INDEPENDENT REVIEW OF NUREG/CR-2497
"PRECURSORS TO POTENTIAL SEVERE CORE DAMAGE
ACCIDENTS: 1969-1979 A STATUS REPORT"

INDEPENDENT REVIEW OF NUREG/CR-2497
"PRECURSORS TO POTENTIAL SEVERE CORE DAMAGE
ACCIDENTS: 1969-1979 A STATUS REPORT"

February 16, 1983

Figure 5-1. Failure Possibilities for the Browns Ferry Fire (from Refs. 2 and 6).

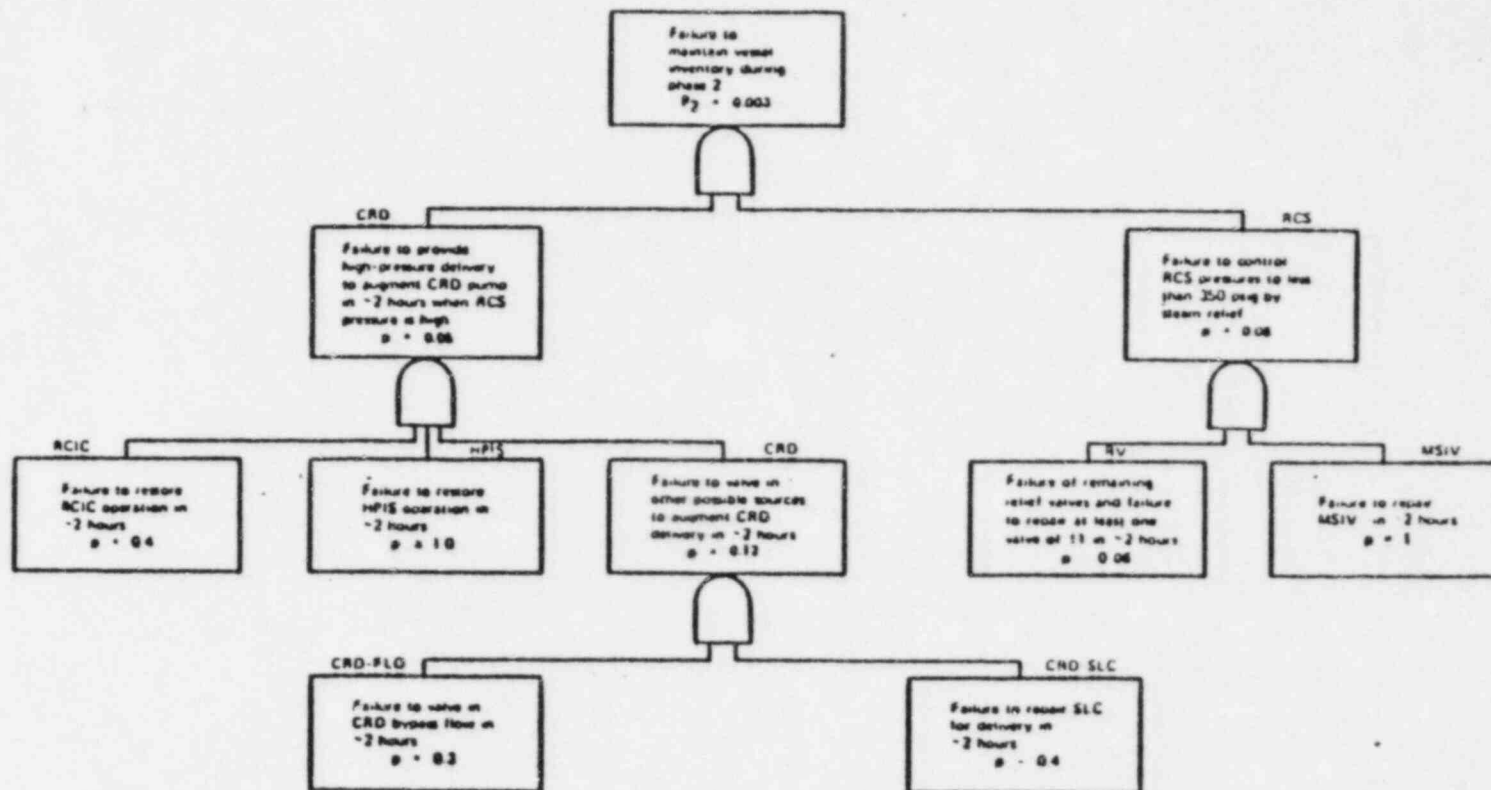
The INPO review (Ref. 2) models the loss of high pressure injection (HPI) function using the fault tree in Figure 5-1 which was taken from WASH-1400 (Ref. 3). This model includes the CRD system as well as repair activities that were in progress for restoring the RCIC and/or the SLC systems. If restored, the RCIC system would have provided an adequate coolant makeup capability. The SLC system would have provided an additional 56 gpm of makeup per pump.

The INPO review (Ref. 2) models the loss of high pressure injection (HPI) function using the fault tree in Figure 5-1 which was taken from WASH-1400 (Ref. 3). This model includes the CRD system as well as repair activities that were in progress for restoring the RCIC and/or the SLC systems. If restored, the RCIC system would have provided an adequate coolant makeup capability. The SLC system would have provided an additional 56 gpm of makeup per pump.

Figure 5-2. Example Event Tree for High Pressure Injection Function at Browns Ferry.

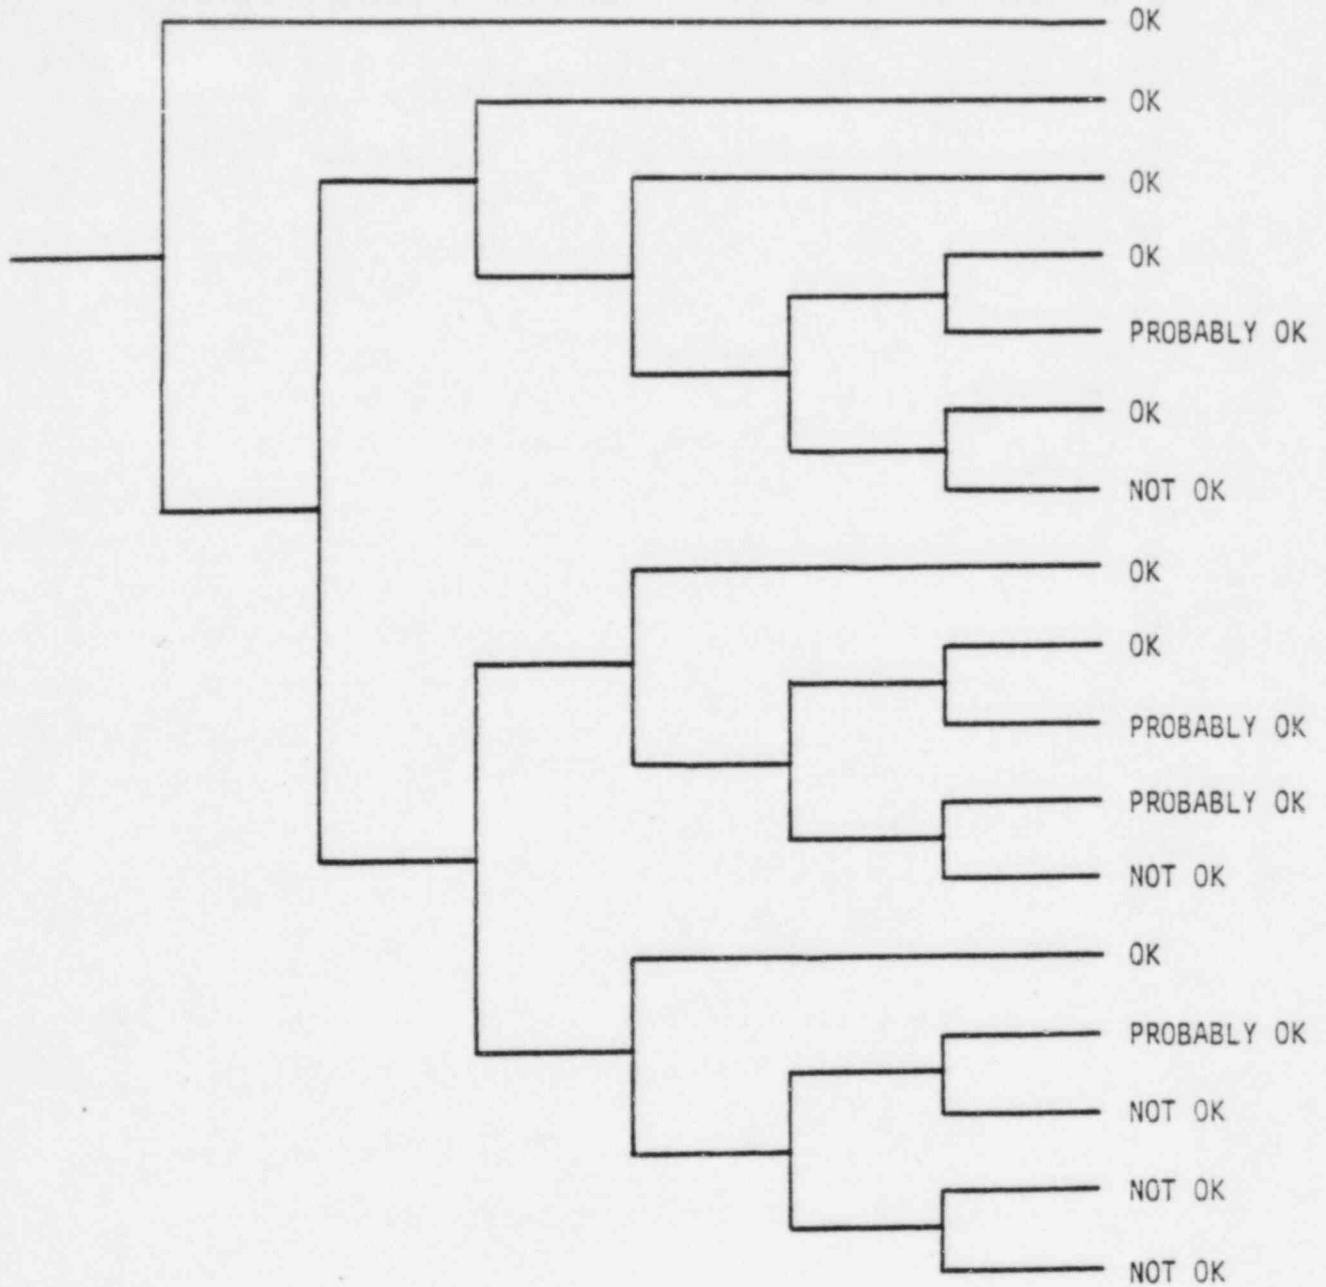
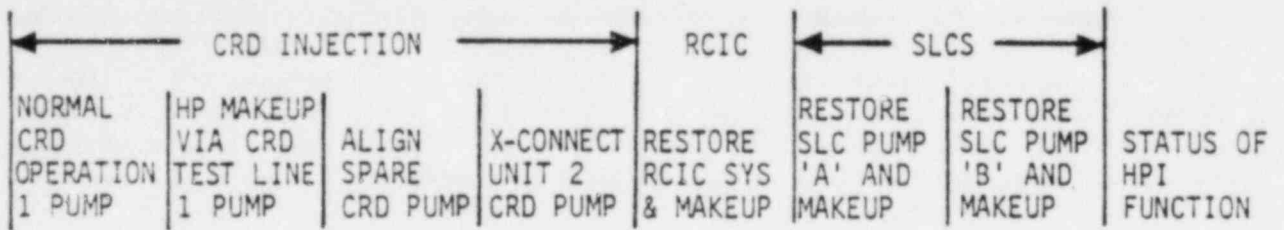
An event tree illustrating an even greater range of system options related to the single event "RCIC/HPCI Response Adequate" in the ASP standard event tree is shown in Figure 5-2. This event tree was developed based on the description of the Browns Ferry fire in References 7 and 8, and includes some system options not found in the fault tree in Figure 5-1.

Thus, we have seen three levels of modeling detail for the same function in a standard event tree. A very simple, conservative assumption of high pressure injection (HPI) unavailability is used in the ASP study. The INPO review references the WASH-1400 fault tree shown in Figure 5-1 to justify a lower probability of HPI unavailability. An even more detailed representation of possible options for restoring the HPI function is shown in Figure 5-2, and this model could be used to calculate yet another failure probability for the HPI function. The important point is that the numerical estimates of function failure probability are affected by the depth of the supporting system model, and, of course, by the data used to quantify the model.

Figure 5-3. Example Fault Tree for Loss of Depressurization Capability at Browns Ferry.

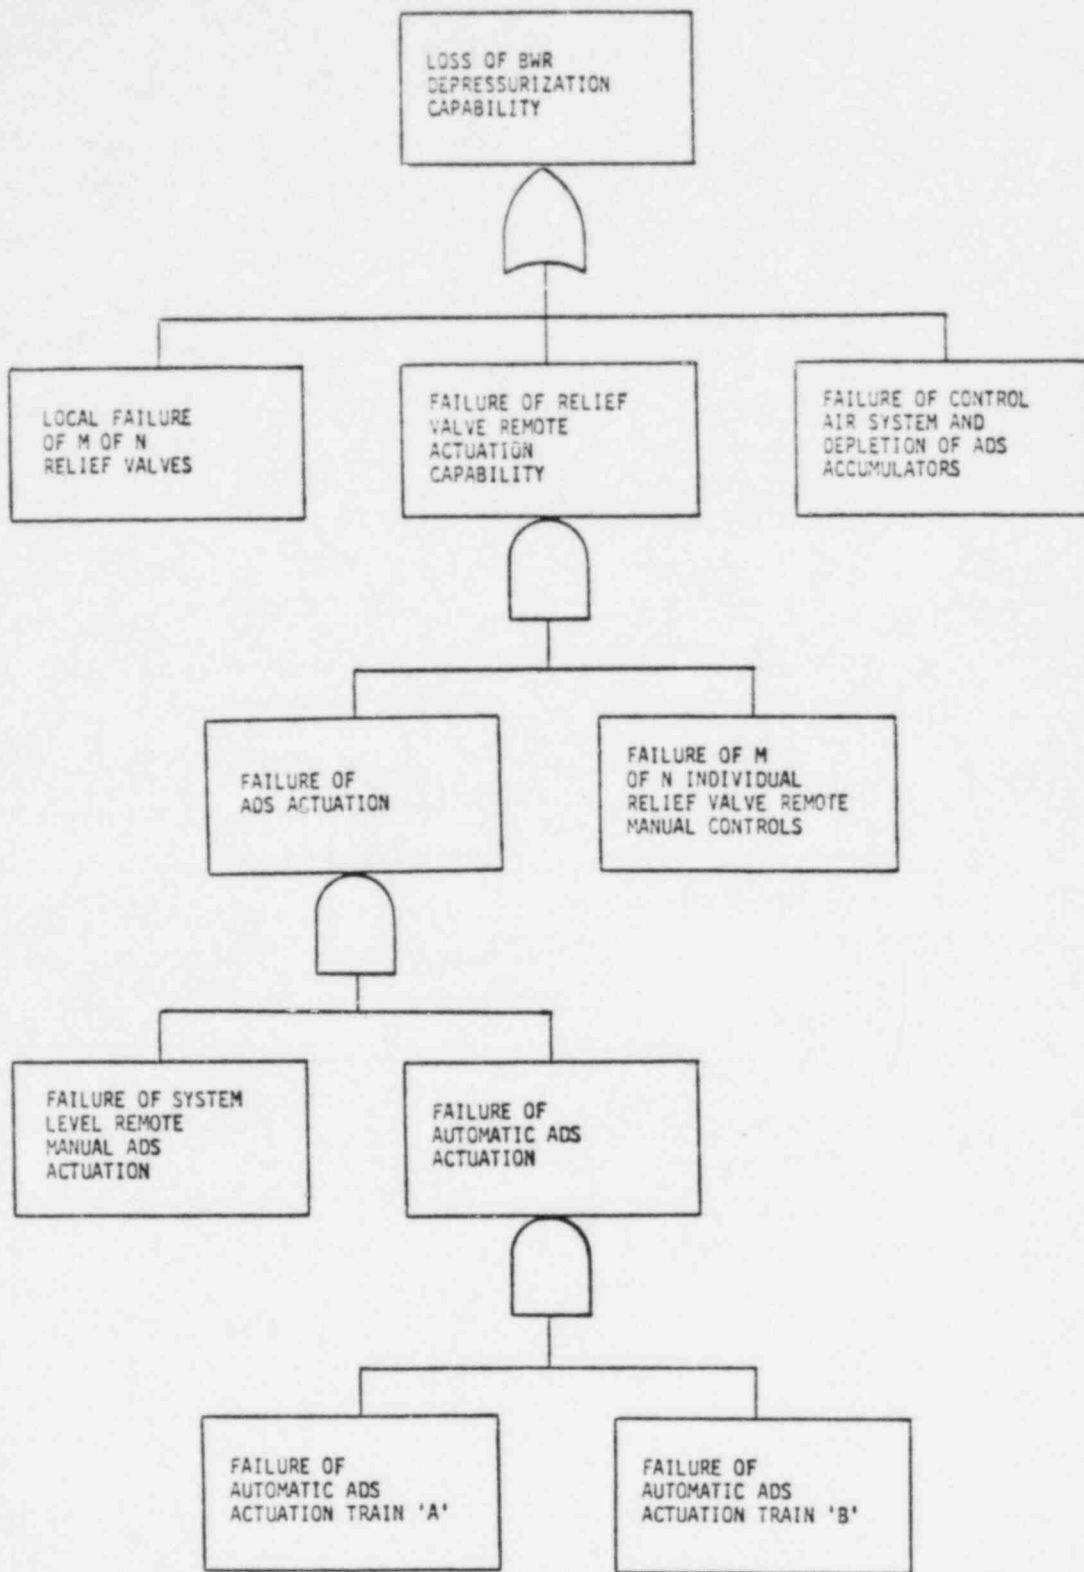
The RCS depressurization capability was lost during the Browns Ferry fire as a result of loss of control air and depletion of the air supply in the accumulators for the ADS valves. A solenoid valve had failed closed in the common air supply line serving the ADS valves. Manual actions were necessary to bypass the failed valve and reestablish control air. It has been noted that the bypass action took 3.5 hours to accomplish (Ref. 7). The loss of depressurization function was not modeled in detail in either the ASP study or the INPO review. A relatively simple fault tree representation for loss of the depressurization function is shown in Figure 5-3. Each event in this fault tree could, of course, be modeled in much greater detail.

The condensate and booster pumps depend on offsite power, but the other pumps can be supplied from the diesels. A detailed event tree or fault tree of loss of the LPI function could be developed, and would provide the basis for an estimate of the probability of loss of the LPI function (within the limitations imposed by the available data). A detailed model was not used in either the ASP study or the INPO review.

Figure 5-4. Reliability Characterizations for AFS Designs in Plants Using the Westinghouse NSSS.

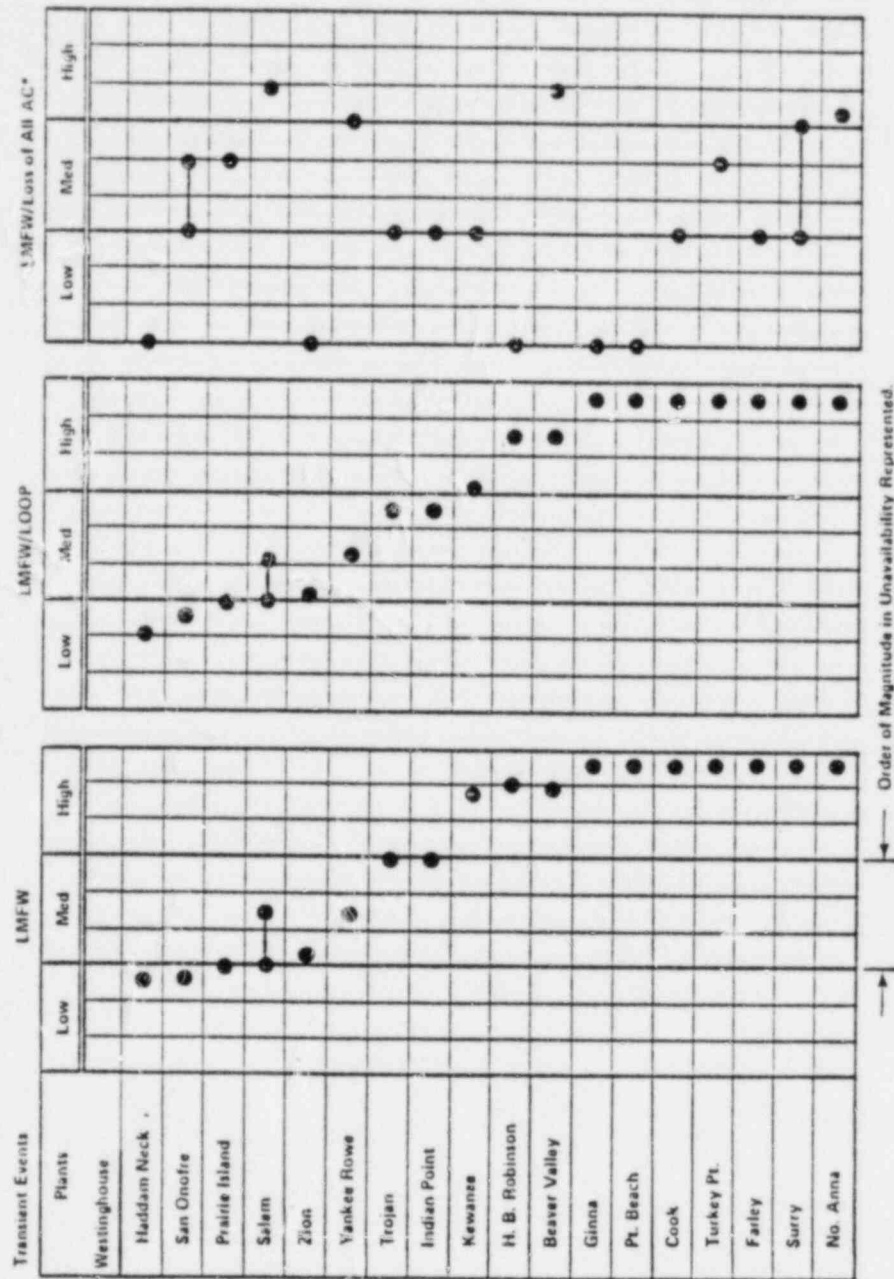
Subjectively, Figure 5-4 illustrates that AFW system reliability estimates range from "low" to "high". On a more quantitative basis, this range depicts differences of as much as two orders of magnitude in the estimated reliability of AFW systems. The difference between the NUREG and INPO reliability estimate for a "generic" AFW system seems, therefore, relatively small considering the range of plant-specific AFW system reliability estimates shown in Figure 5-4. It is interesting to note that more than half of the LERs used in the ASP study to calculate AFW and secondary heat removal failure probability occurred at Westinghouse plants that were ranked in NUREG-0611 as having rather

A further point of interest in Figure 5-4 is that system reliability can be improved significantly (e.g., by up to an order of magnitude) when dominant system failure modes are eliminated or reduced. Once improvements are made, the plant no longer "looks" the same as it did before. The effects of such improvements are excluded from the ASP study, but should result in lower system failure probability and/or initiating event probability in the future. The 11-year period covered by the ASP study is long enough that any improvements made as a result of events early in the study period will adversely affect the applicability of the failure data in the latter part of the study period, and certainly beyond 1979.

Figure 5-5. Comparison of ASP and INPO Assessments Of the Browns Ferry Fire.

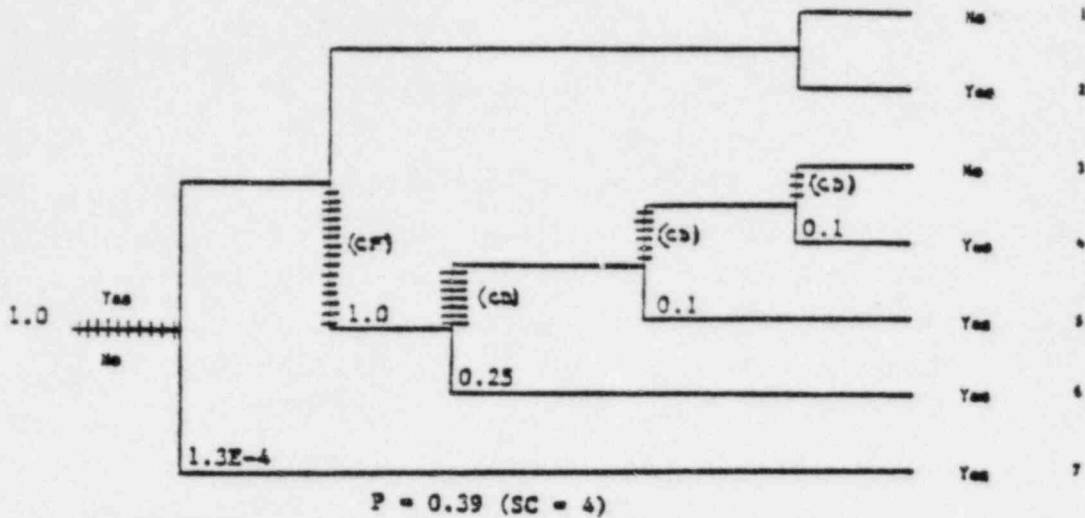
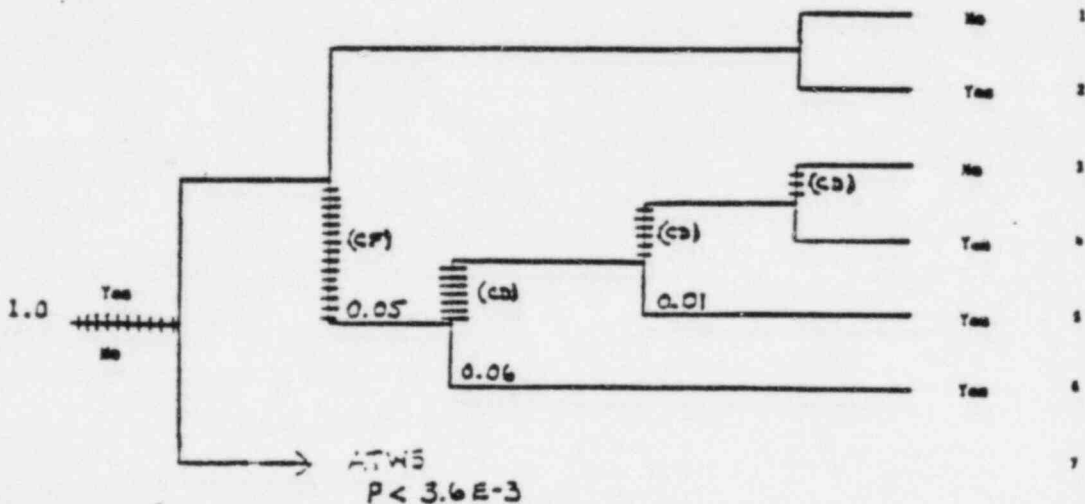
dures" are somewhat different than that of the ASP study group. These factors introduce a systematic bias that virtually ensures that the ASP and INPO results will be consistently different. A summary of the ASP and INPO conditional probabilities of severe core damage is shown in Table 5-8. It is instructive to note that the INPO values (with only one exception) are all lower probabilities. As can be seen in Figure 5-5 (Browns Ferry fire, from Ref. 2), the ASP and INPO assessments both are based on comparable event trees, but significantly different data are used in quantification of the event tree. Systematic bias of the ASP and INPO groups is believed to be a significant contributor to the differences between their respective estimates. While methodologies exist to perhaps resolve these differences (Ref. 10), it is beyond scope of this review to do so.

Figure 5-6. Comparison of ASP Results With Other Core Damage Estimates (From NUREG/CR-2497).

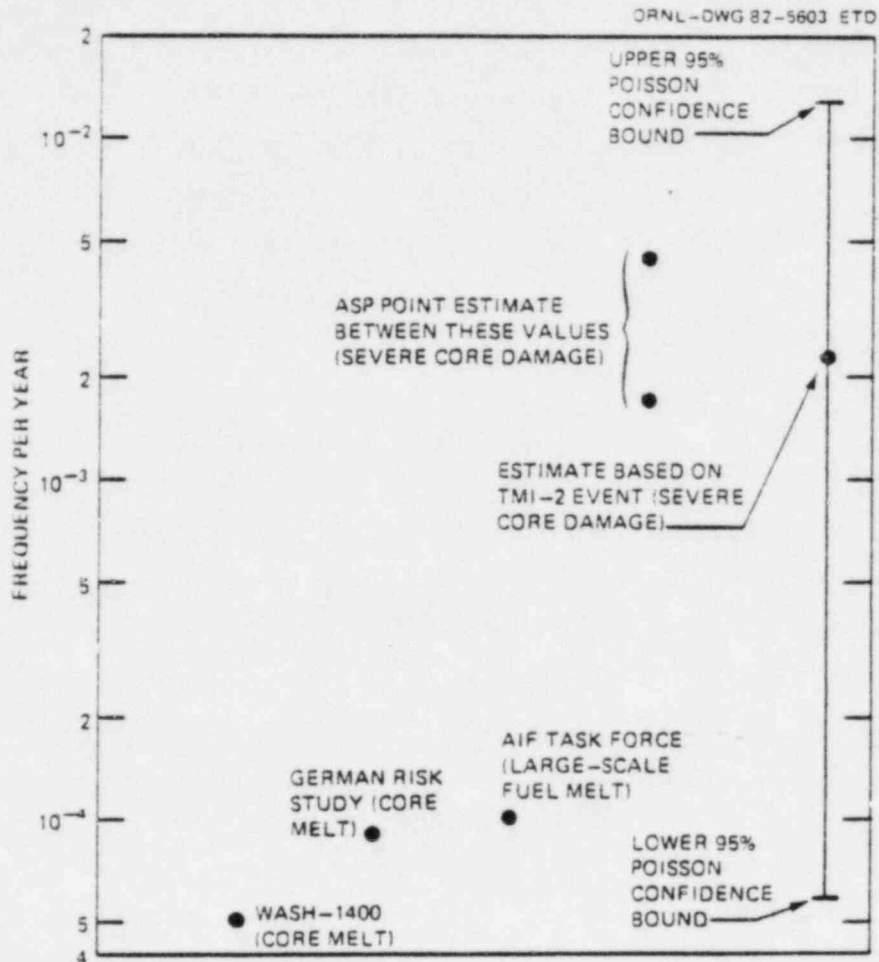
results for all precursors. The validity of this technique was questioned by INPO due to the adding together of actual failures with the probability of failure for those sequences which were actual successes.

Comparison of specific estimates of core melt frequency from a PRA with the ASP indicator of severe core damage frequency has no real meaning of itself. By including the illustration shown in Figure 5-6, the ASP study implied that such comparisons could be made. Comparison of the ASP indicators of severe core damage frequency derived for different time periods should provide insight on plant-specific and industry-wide performance.
